BROWN/HANBERG ESTATES SUBDIVISION

APPLICATION NUMBER 22 DATE July 19, 2007

APPLICANT Brown/Hanberg Subdivision

REQUEST Subdivision

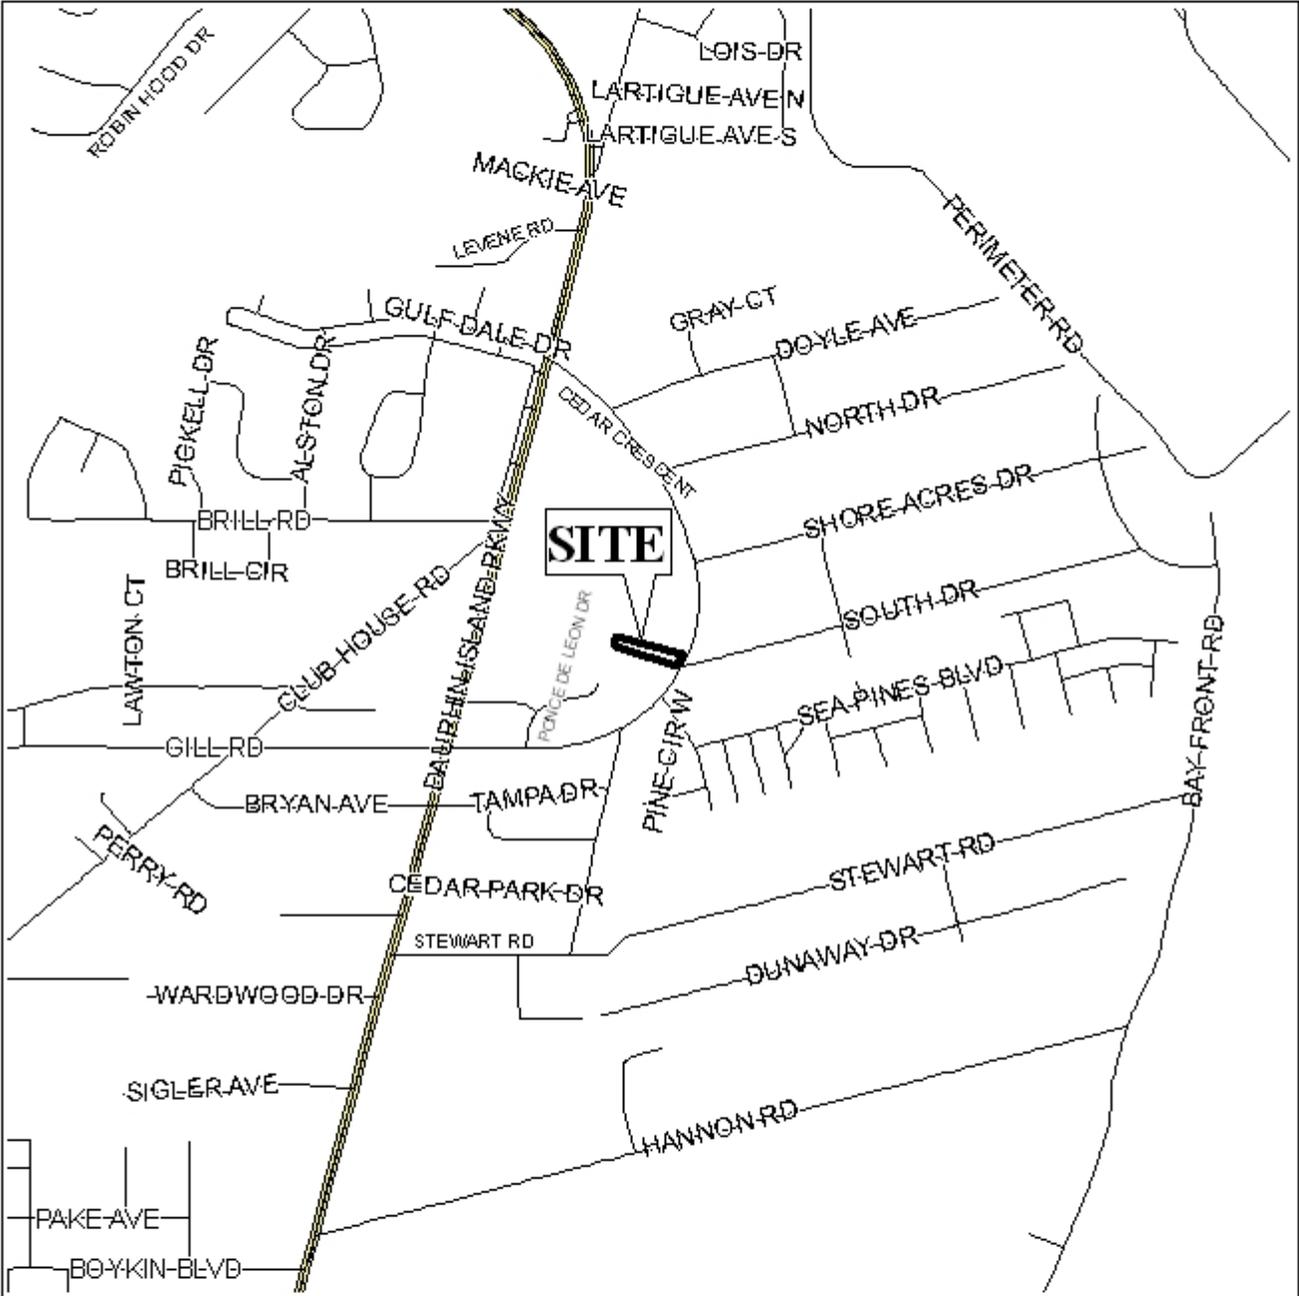
On the plat, Cedar Crescent is labeled as “Cedar Crescent Drive” and this should be corrected to read “Cedar Crescent” on the final plat.

The site exceeds the maximum width to depth ratio as recommended by Section V.D.3. of the Subdivision Regulations. However, narrow, deep lots are typical in this neighborhood; thus a waiver of V.D.3. would be appropriate.

The site fronts on Cedar Crescent; therefore a note should be placed on the final plat stating that each lot is limited to one curb cut with the size, location, and design to be approved by Traffic Engineering.

The 25' minimum building setback lines for both the front and rear lots are indicated on the plat, and these should also be indicated on the final plat.

No square footage for each lot is indicated on the plat submitted; therefore, the plat should be revised to label each lot with its size in square footage, or there should be the provision of a table on the plat depicting the same information.

With a waiver of Section V.D.3. (width to depth ratio), the plat will meet the minimum requirements of the Subdivision Regulations and is recommended for Tentative Approval subject to the following conditions:

- 1) correction of the street name label to “Cedar Crescent” instead of “Cedar Crescent Drive”;
- 2) placement of a note on the Final Plat stating that each lot is limited to one curb cut with the size, location, and design to be approved by Traffic Engineering;

- 3) depiction of the 25’ minimum building setback lines for each lot as shown on the preliminary plat;
- 4) revision of the plat to label each lot with its size in square feet, or provision of a table on the plat depicting the same information; and
